PIC18F26/46/56Q71 Silicon Errata and Data Sheet Clarifications

PIC18F26/46/56Q71

Introduction

1.4.1 UART TXDE Signal May Go Low before the STOP Bit Has Been Entirely Transmitted

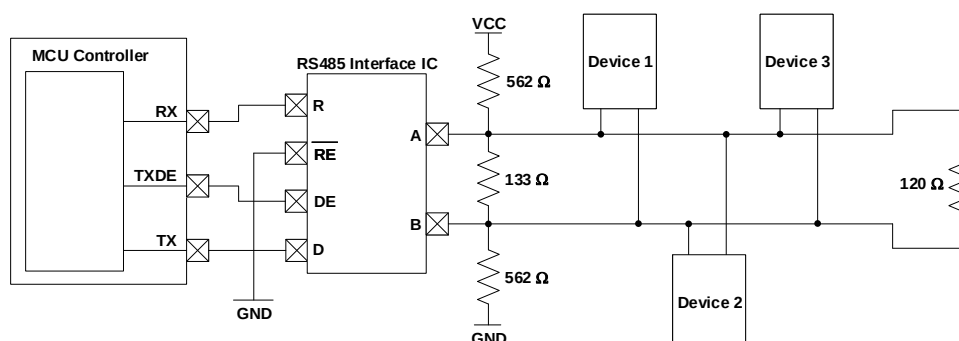
The UART Transmit Drive Enable (TXDE) signal could potentially transition into a low state before the UART STOP bit has been entirely transmitted due to the effects of parasitic capacitance on the TX line. In some applications, this could result in communication being prematurely terminated due to the TXDE bit going low before the STOP bit has had enough time to settle.

To ensure that the STOP bit settles into its final logic state before the TXDE signal transitions low, a biasing circuit can be implemented. A biasing circuit allows the TX line to either be driven high or low, rather than being left in a floating tri-state mode where prolonged rise or fall times could lead to communication being disrupted. This bias circuit should only be implemented on one end of the serial bus, and a termination resistor should be used on the other end. The figure below shows an example of a bias circuit that can be used to achieve this.

Please note that the resistor values used in this circuit are recommendations and that the actual resistor values required may vary based on the application.
